ADDENDUM No.1

Chase Brook Park Restoration and Pedestrian Bridge

Addendum No. 1: This Addendum provides answers to questions raised by prospective bidders for the Chase Brook Park Restoration and Pedestrian Bridge project.

3. Erosion Control Limits / Legend Clarification

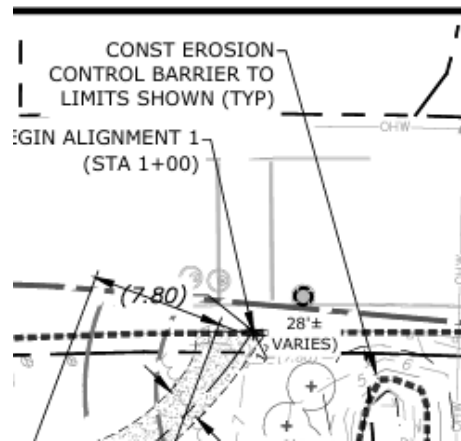
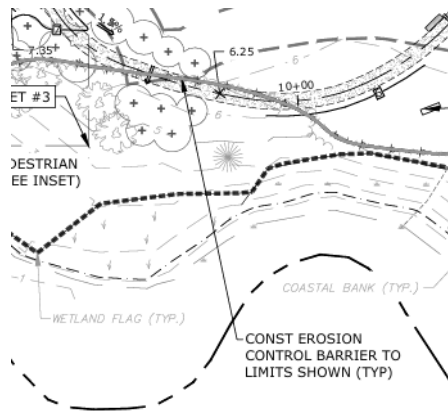
Question: The plans reference erosion controls but do not include a legend, and some erosion control callouts appear to cross directly over the stabilized stone dust pathway or point to the limit-of-work line. There are two areas where erosion controls are labelled but pointing to different lines. Can you please provide a legend or clarify the intended erosion control limits shown on the drawings? See Pics below.

A: The Town is in the process of clarifying the discrepancy on the drawings for the erosion controls, however, at a high level, the contractor is responsible for controlling any/and all erosion on site.
